Greenwich Community Association Inc

St Leonards Plaza Design Submission

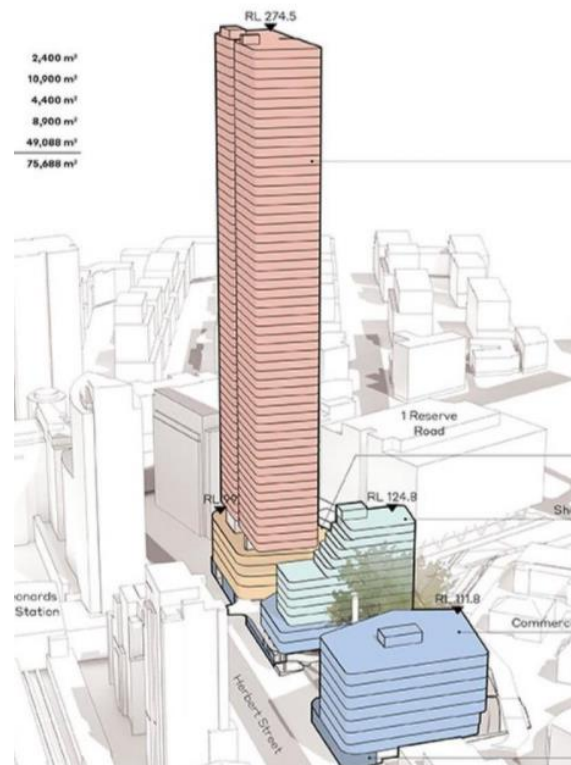
Further modelling required to assess anticipated overshadowing of plaza by approved/proposed developments on the east side of Pacific Highway.

Given that the expenditure on the plaza will be significant and the plaza is intended, presumably, to be in place for several years, it was surprising to hear at the presentation that Council only takes completed buildings into account for the purposes of solar analysis.

We submit that Council should address future development in the precinct and the impact of this development on the amenity of the plaza as this will, in turn, inform the best placement of elements and planting.

It is noted that there are several tall buildings contemplated in the St Leonards Crows Nest Plan that will, potentially, overshadow the plaza.
